Project	Bonhams Field, Yapton
Project Number	23018
By	Stuart Magowan IEng MICE
Date	16 March 2023

Bonham's Field, Yapton

Drainage Verification Report

Project	Bonham's Field, Yapton
Document Title or Subject	Drainage Verification Report -- Plots 19-21
Document Reference	104367-PEF-ZZ-XX-RP-CD-000603
Revision Reference	S2-P03
Date	27 th January 2023

Table 4.1 Photographs of SW Drainage for Plots 19-21 from Site Visit on 04/07/2022

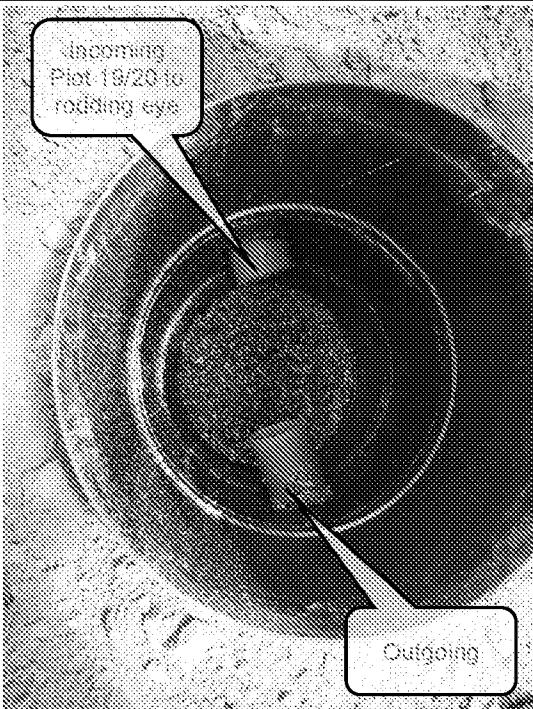
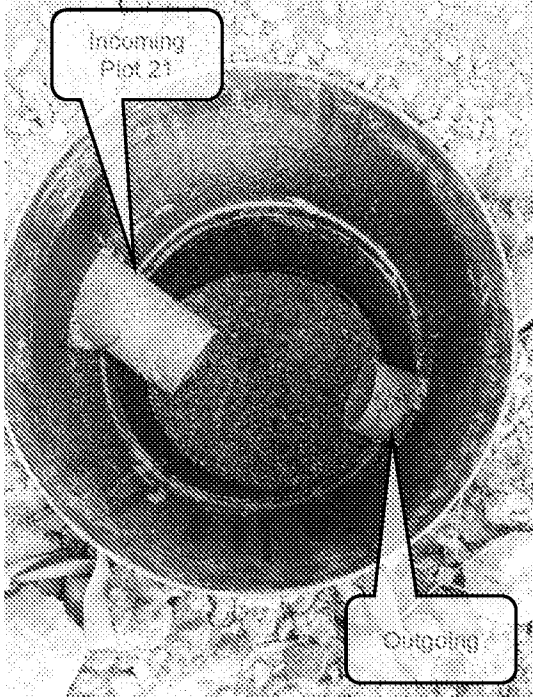
Photograph	Manhole ref (refer to 'as-built' drawing)	Comments
	SW26	SW26 configuration, observed as a catch pit arrangement. Incoming pipe from rodding eye observed as 100mm diameter, as-built drawing notes this as 150mm diameter. Incoming pipe direct to manhole from RWP on Plot 20 not present, could not be confirmed whether this was put online of upstream pipe. Outgoing pipe observed as 100mm diameter, as-built drawing specifies 150mm diameter. It was also noted that the invert level of the outgoing pipe appeared higher than incoming pipe. Survey will be needed to confirm correct invert levels and/or relay as required.
	SW35	SW35 manhole configuration, catch pit arrangement. Incoming pipe assumed from RWP at Plot 21 as 100mm diameter pipe. Outgoing pipe to diffuser tank observed as 100mm diameter, as built drawing specifies this as 150mm diameter.

Table 4.2 Photographs of SW Drainage for Plots 19-21 from Parchow Groundworks Ltd on 27/07/2022

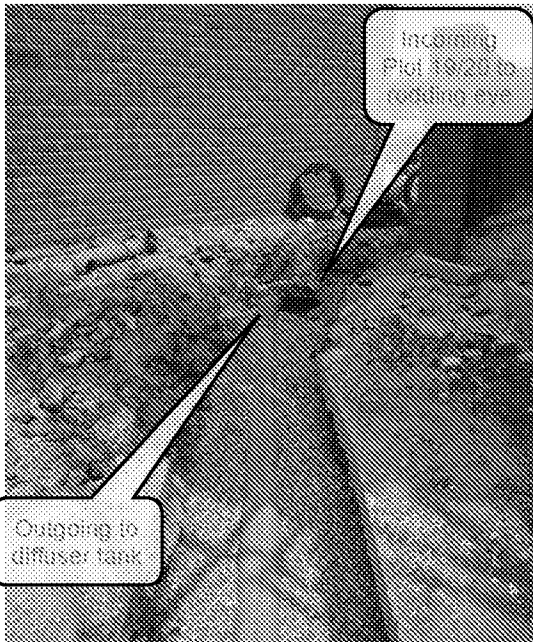
Photograph	Manhole ref (refer to 'as-built' drawing)	Comments
	S34 CP	S34 CP configuration, observed as a catch pit arrangement. Incoming pipe from rodding eye, second incoming pipe direct to manhole from RWP on Plot 19 rather than upstream connection as per drawings. Outgoing pipe to diffuser tank.
	SW77	SW77 manhole and pipe run to diffuser tank.

Photograph	Manhole ref (refer to 'as-built' drawing)	Comments
	SW26	SW26 drainage infrastructure. Base of catch pit installed, upper ring to be installed with pipes to be set in. Incoming pipe from RWP's on Plot 19/20, confirmed by Parchow Groundworks Ltd to be 150mm diameter. Outgoing pipe noted as 150mm diameter as specified on 'as-built' drawing.
	SW29	SW29 manhole in situ. Incoming pipe from RWP on Plot 20, confirmed by Parchow as 100mm diameter. Outgoing pipe to diffuser tank. Noted as 150mm diameter as per 'as-built' drawing.

4.4.1 Following feedback from the Pell Frischmann site visit, Parchow Groundworks Ltd has relaid key elements of the drainage system around Plots 19-21. Photographs are included in Table 4.2.

Figure 4.1 Surface Water Drainage for Plots 19-21

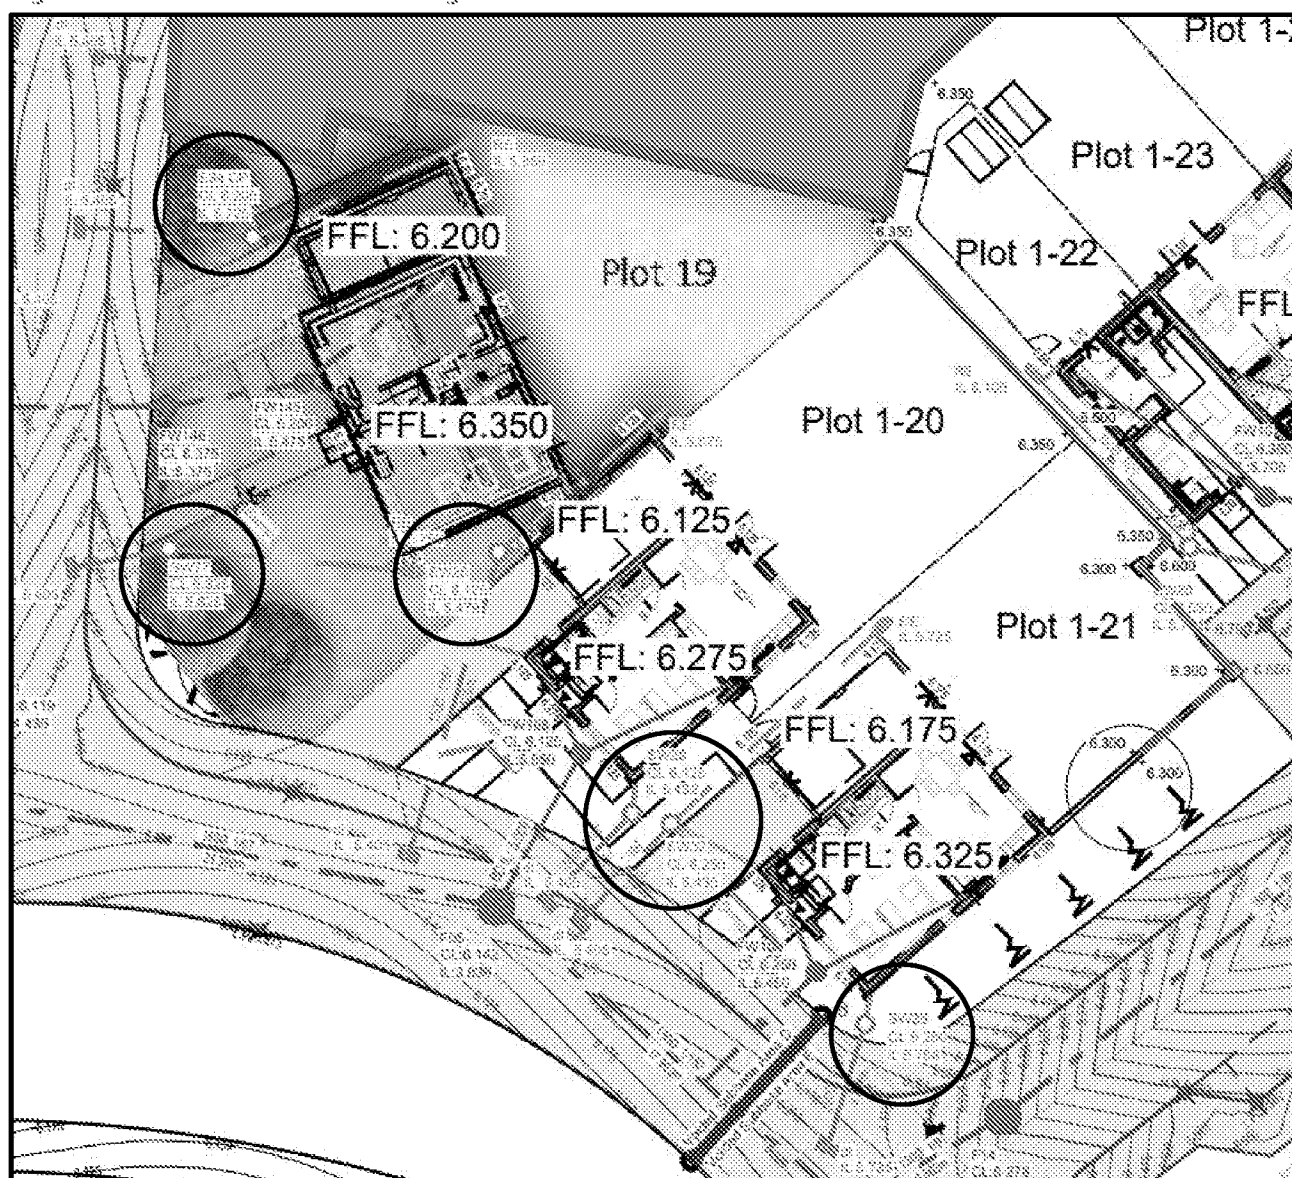
- 4.5.1 Following the recommended remedial works, Parchow Groundworks Ltd has provided a subsequent survey of the surface water drainage infrastructure for Plots 19-21 (see **Appendix D**). This included invert levels of the 6 manholes required to serve these plots, as shown on the extract from the CEP design drawings in **Figure 4.1**.

4.5.3 In all cases the surveyed manhole invert levels accord with the design levels prepared by CEP, and gradients are likely to remain as per the designs, subject to suitable installation of the diffuser tanks. The installed drainage will therefore likely operate in accordance with the pipework design gradients as discussed within Section 3.2 of this report,
